2. Lloyd race Lot 4 Replat; KPB File 2022-157

LLOYD RACE LOT 4 REPLAT

ITEM 2 – LLOYD RACE LOT 4 REPLAT

STAFF REPORT

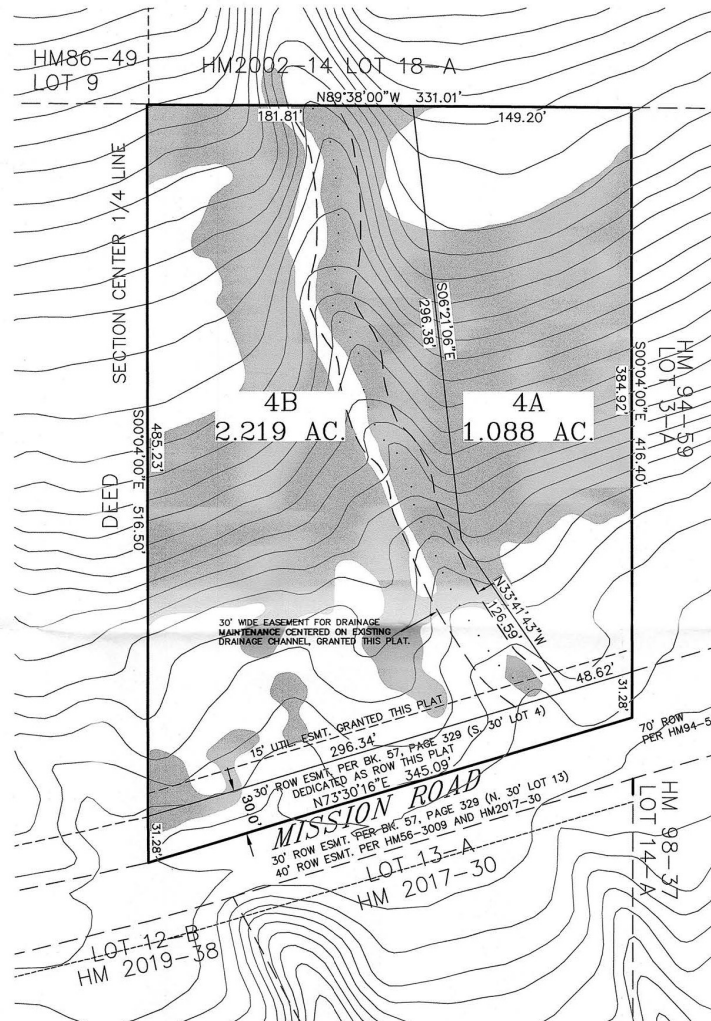
The plat is proposing to grant a 30 foot width dedication to increase the width of Mission Road. The dedication will be atop a right-of-way easement that is noted on the plat. **Staff recommends** add a width label be to the west for Mission Road abutting the subdivision as the right-of-way appears to widen.

Steep terrain appears throughout the majority of the proposed plat. Due to the amount of steep terrain present, **staff recommends** the areas with over 20 percent grade should be shown on the final plat.

Imagery shows multiple items in place on the property but KPB Assessing data does show the property vacant. Many of the items do appear to be not permanent in nature. **Staff recommends** the surveyor verify that there are no permanent structures that will be encroaching over the new property line or within the new dedication and utility easement.

Plat note 4 notes a recorded easement is present. It was not included with the certificate to plat. If the property is subject to the easement, work with the title company to get added to the report. If the easement is not for this property, please remove the plat note.

- B. North point;
Staff recommendation: Add north arrow for drawing. Only north arrow given is inside vicinity map box. Add scale.
- G. The status of adjacent lands within 100 feet of the proposed subdivision boundary or the land status across from any dedicated rights-of-way that adjoin the propose subdivision boundary, including names of subdivisions, lot lines, block numbers, lot numbers, rights-of-way; or an indication that the adjacent land is not subdivided;
Staff recommendation: Correct some overstrikes on southern lots. Mission Road width varies but provide an overall width label for the portion adjoining the subdivision.

- J. Block and lot numbering per KPB 20.60.140, approximate dimensions and total numbers of proposed lots;
Staff recommendation: Provide a tract or lot label for each new division number. They have been noted as Lots elsewhere in this report, specifically the exception request.

Staff recommendation: Include the drainage easement within the acceptance for the City of Homer.

It appears that plat notes 3 and 5 are duplicate and one may be removed.

Plat note 4 did not appear on the certificate to plat. If the lots are subject to the easement please have the title company update the CTP.

Staff recommendation: Verify which state the owners will be signing in and update or leave blank. Comply with 20.60.190.

I've checked Lot 4A a couple of times and keep finding the depth to width is 3.1:1. Please request an exception.

I hereby ask for an exception to the 3:1 Depth to width ratio. KPB says the ratio of the Lot 4A is 3.1:1. The request is based on topographic constraints and assertion of spouse that she needs the line drawn that way for her terms of divorce. A drainage seems to be the limiting criteria.
